**VILLAGE OF WINDSOR
BOARD RESOLUTION 2016-44**

**APPROVAL OF
FINAL REPLAT OF WINDSOR CROSSING
(SINGLE FAMILY RESIDENTIAL-74 LOTS)**

Staff Review

RE: Windsor Crossing - Final Replat Request

PHASING PLAN
VILLAGE OF WINDSOR, WI
REVISED 03.02.16

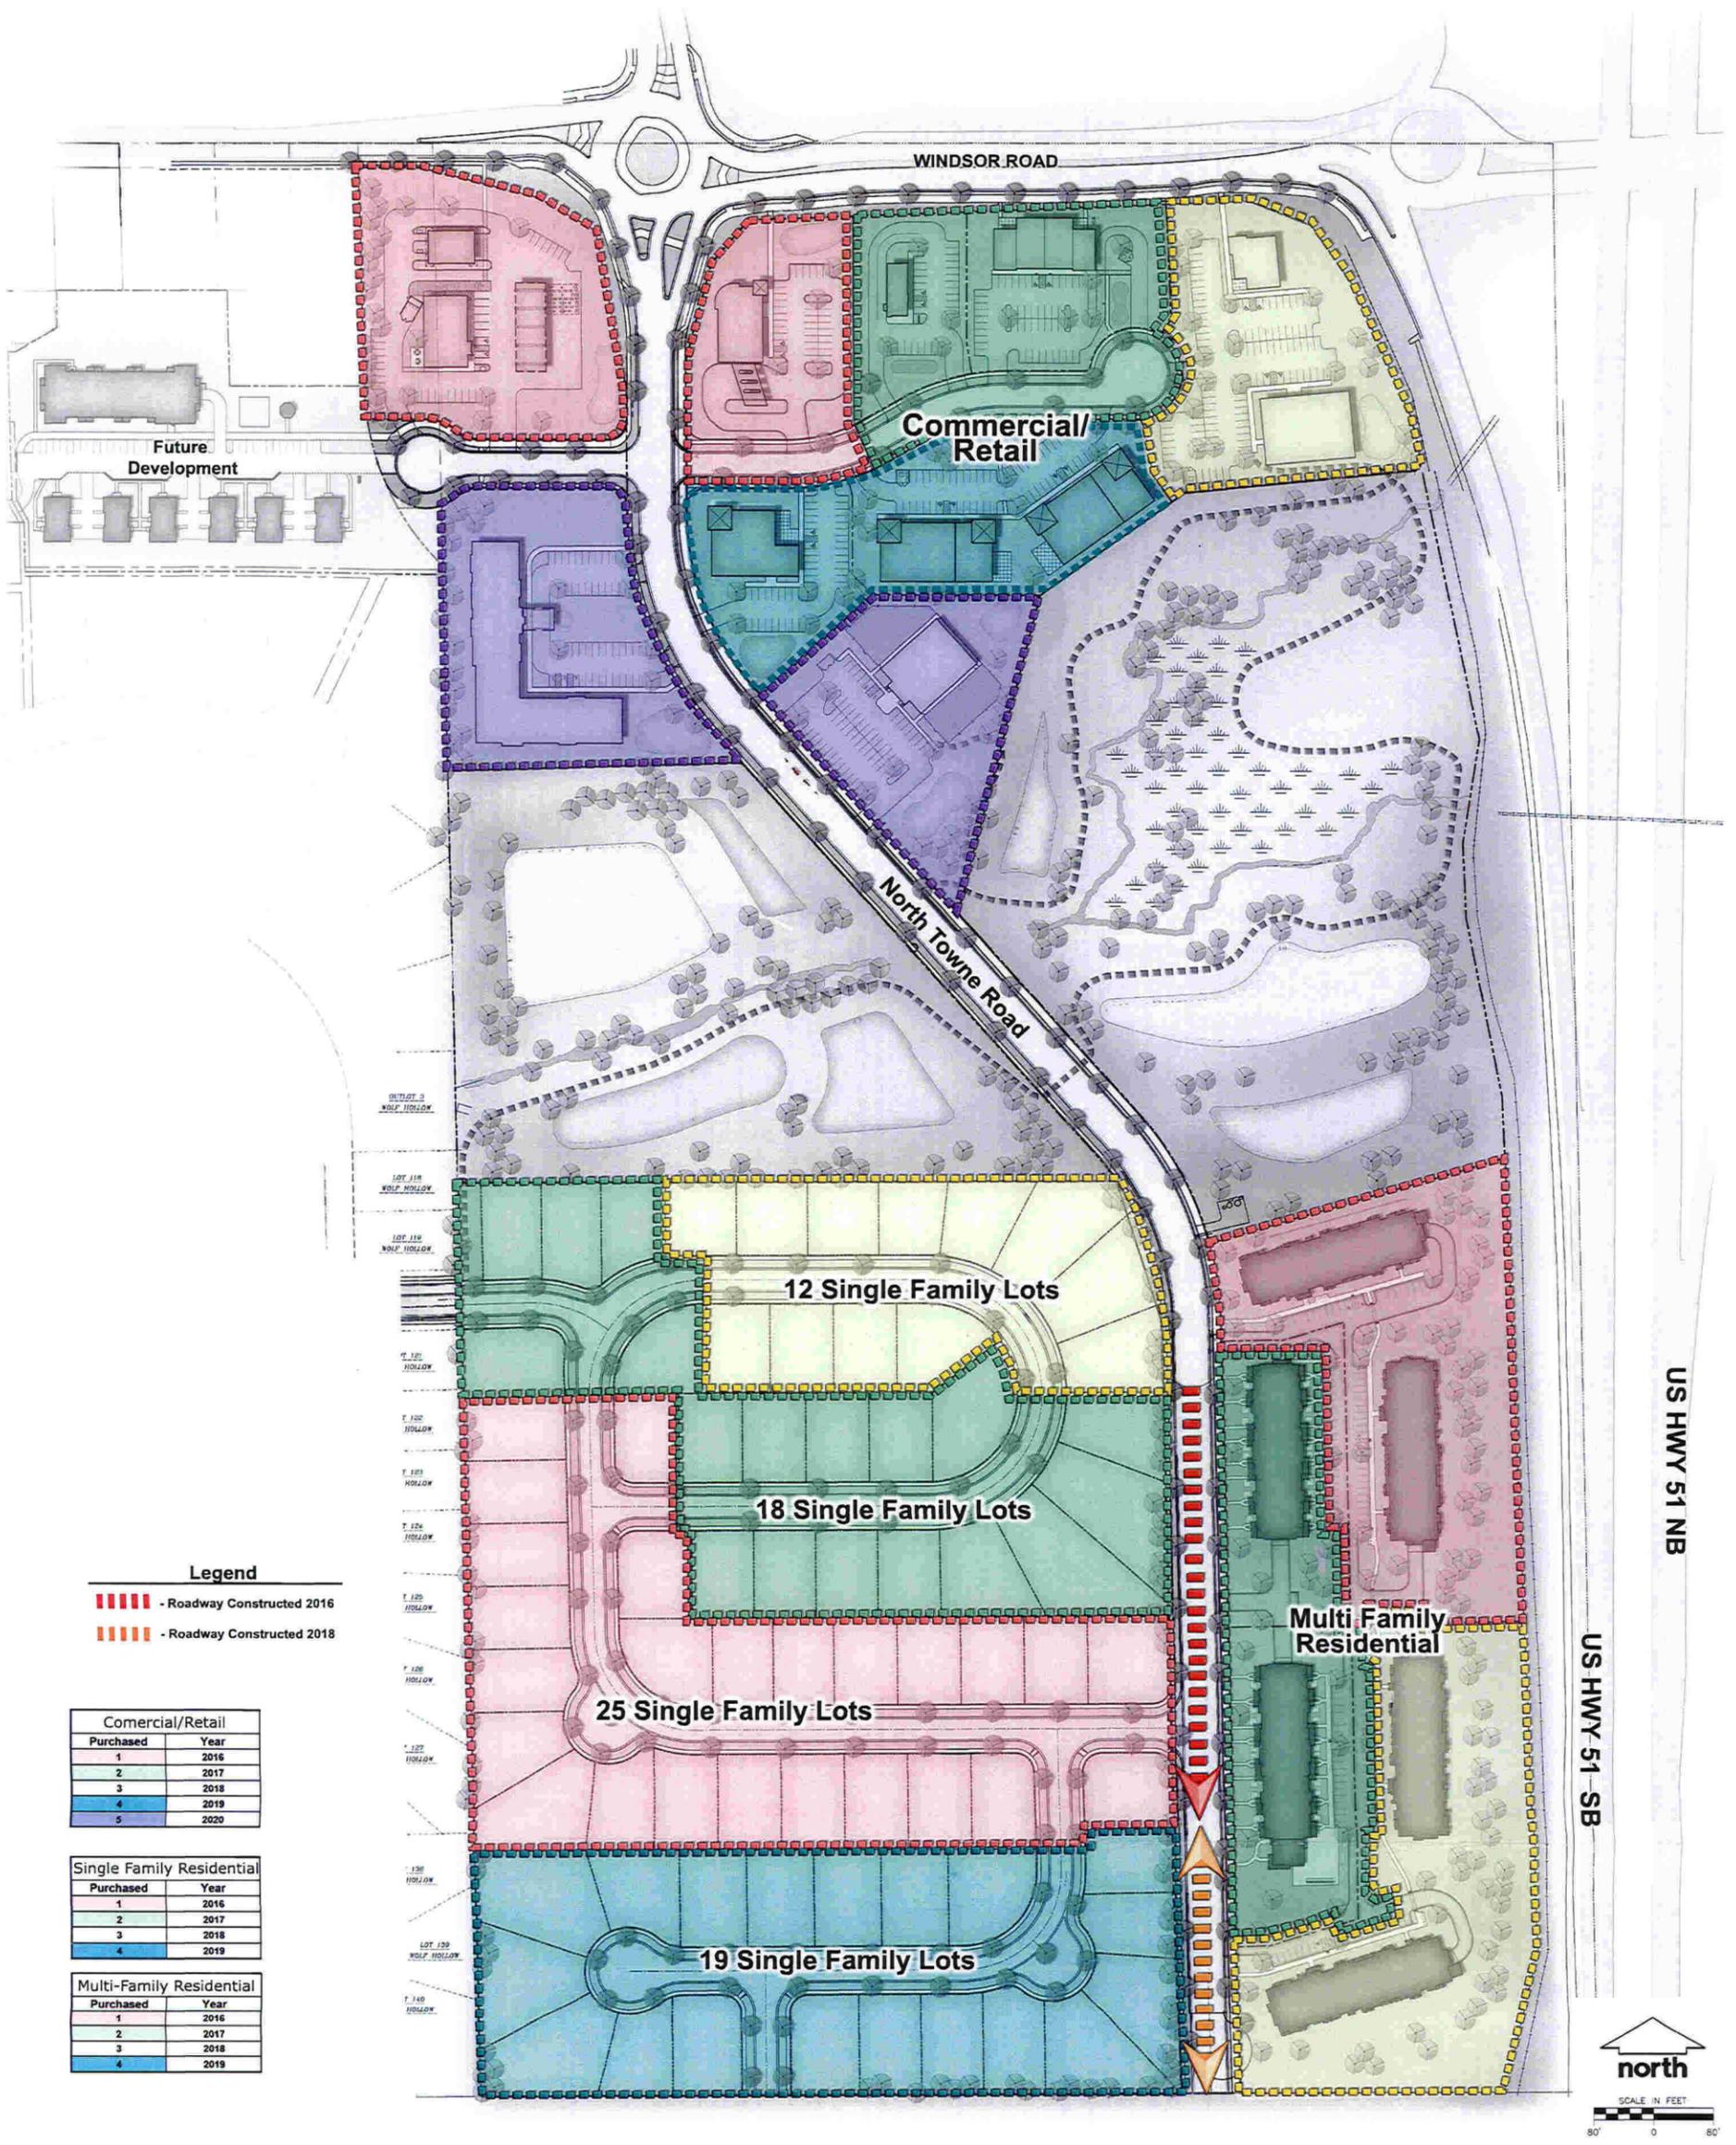
The submitted Phasing Plan for the Final Replat of Windsor Crossing does not meet the intent of the above stated conditions. The Village of Windsor Plan Commission and Village of Windsor Board should discuss with the Petitioner a resolution to this matter.
